Product / Process Change Notification (PCN)

PCN #: PCN_IndPD_20181008

Affected Series: WE-PD-Series
 744778xxx
 744777xxx

Current: PVC Tube	New: PET Tube
 <p data-bbox="592 584 695 629">PVC</p>	 <p data-bbox="1235 584 1339 629">PET</p>
Finished Good	Finished Good

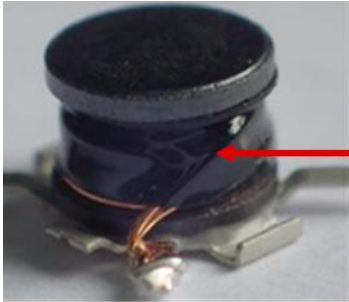
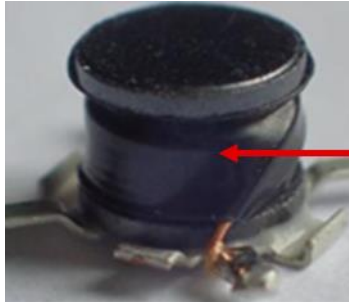
In line with the adoption of industry standards, Würth Elektronik will change the shrink tube material from PVC to PET to reduce the content of halogen afflicted materials.

It is necessary to protect the wire isolation from further production steps. The shrink tube is covering and protecting the winding.

To meet international environmental requirements Würth Elektronik is changing the tube from PVC to PET material. The PET material is not containing any substances which are forbidden by RoHS, Reach or Halogen Free standards.
